**THE ROVER COMPANY LIMITED**  
**S E R V I C E   D E P A R T M E N T**

**Rover Service News Letter No. 40**

January 29th, 1954

**Item 2    JIG BLOCK FOR CYLINDER BORING LAND-ROVER AND CAR**

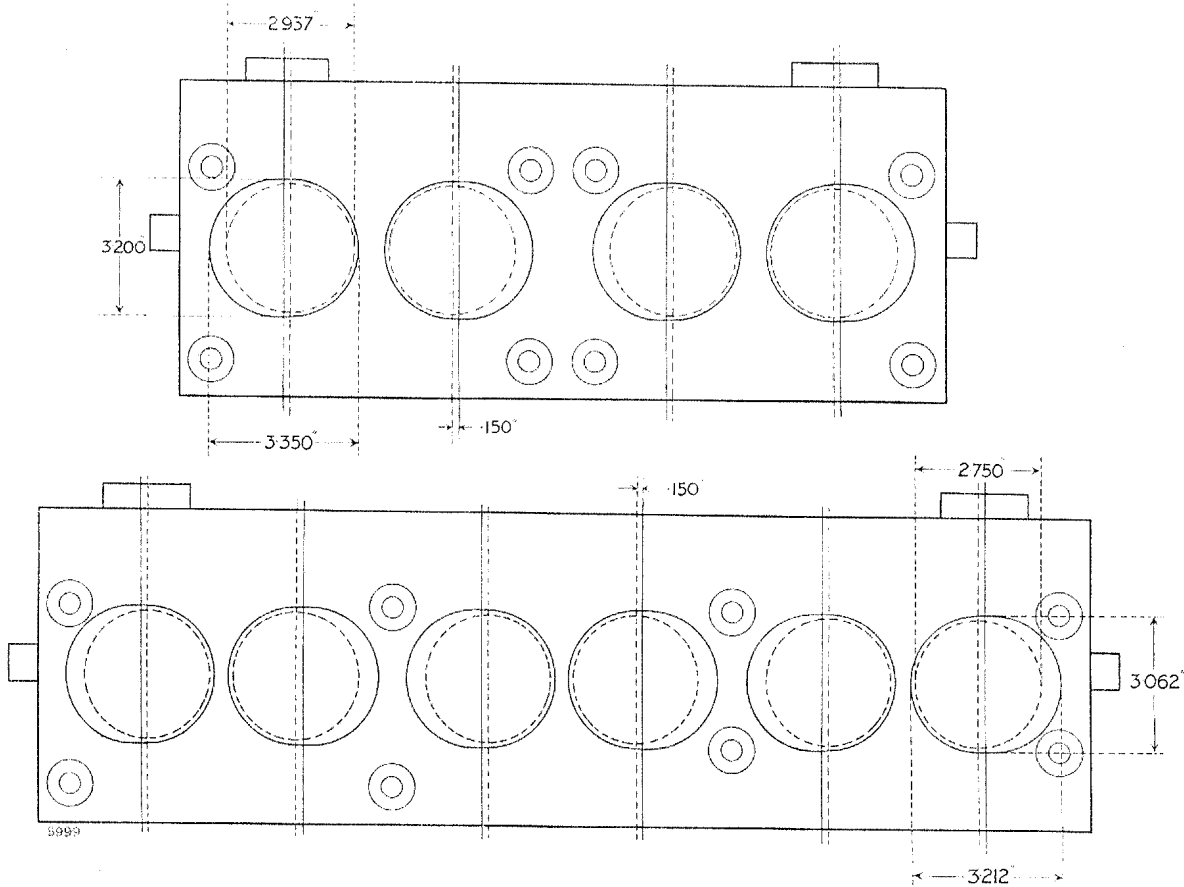
All Service stock of Jig blocks, part numbers 261287 and 261288, have been modified to make them suitable for the 1954 "60" and "75" and "90" respectively. Any stocks held by Distributors or Dealers can be modified as detailed in the sketch below, or alternatively they can be returned to our Service Department, where they will be modified free of charge.

Modification of Jig Block : Bore out, using scrap cylinder blocks to dimensions shown, elongating each bore by .150 in. (3,81 mm). Dotted lines indicate original bore size and centres. Heavy lines show new bore size and centres.
